# Access Compliance Report

## Public Rights-of-Way

### (Curb Ramps)

Intersection ID: 7249	Main Street: HIDDEN_FOREST_DR	Cross Street: TOM_HUNTER_RD	Location: SE
ADA ID: A52FD8526F99	Ramp Type: ParaDiag	Initial Pass/Fail: Fail	Overall Compliance: No
Severity Score: 33.75			
Codes/Mitigation Info/Possible Solution		Field Measurements/Component Compliance

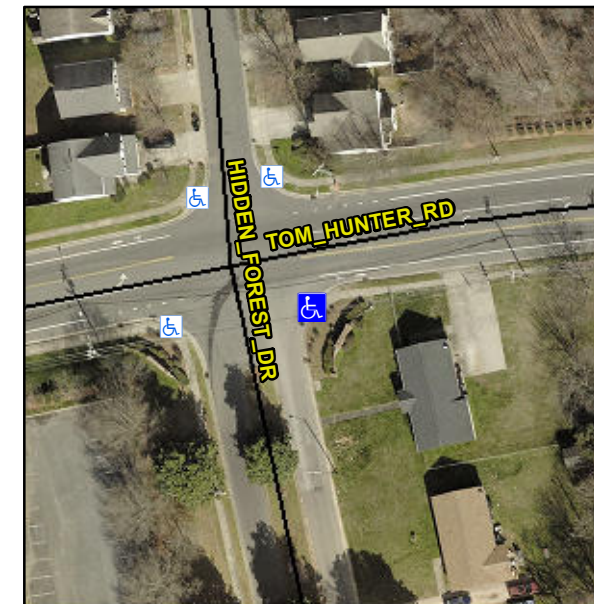
**NO RT SW, RT RP < 5%**

**R304.5.1, R304.3.2, R304.5.3**

Compliance	Description	Data	Compliance	Description	Data
N/A	Ramp Length LT (in)	61.5	N/A	Ramp Length RT (in)	75.0
No	Ramp Width LT (in)	47.5	Yes	Ramp Width RT (in)	61.0
No	Ramp Slope LT (%)	8.9	Yes	Ramp Slope RT (%)	1.6
No	Ramp XSlope LT (%)	6.1	No	Ramp XSlope RT (%)	6.6
N/A	Landing Length (in)	N/A	N/A	DWS Provided?	N/A
N/A	Landing Width (in)	N/A	N/A	DWS Contrast?	N/A
N/A	Landing Slope (%)	N/A	N/A	DWS Length (in)	N/A
N/A	Landing X Slope (%)	N/A	N/A	DWS Full Width?	N/A
N/A	Landing Curb? (Y/N)	N/A	N/A	DWS Offset (in)	N/A
N/A	Shared Landing?	N/A			
N/A	Gutter Ponding?	N/A	N/A	Gutter Slope (%)	N/A
N/A	Gutter Lip Ht (in)	1.0	N/A	Gutter X Slope (%)	N/A
N/A	Painted X Walk1?	No	N/A	Painted X Walk2?	No
	X Walk 1 Direction	To N		X Walk 2 Direction	To W
N/A	X Walk 1 Width (in)	N/A	N/A	X Walk 2 Width (in)	N/A
	X Walk 1 Slope (%)	2.2		X Walk 2 Slope (%)	0.8
	X Walk 1 X Slope (%)	2.9		X Walk 2 X Slope (%)	3.1
N/A	Ramp inside XWalk1?	N/A	N/A	Ramp inside XWalk2?	N/A

**Remove & Replace Curb Ramp With Two New Directional Ramps or Equivalent.**
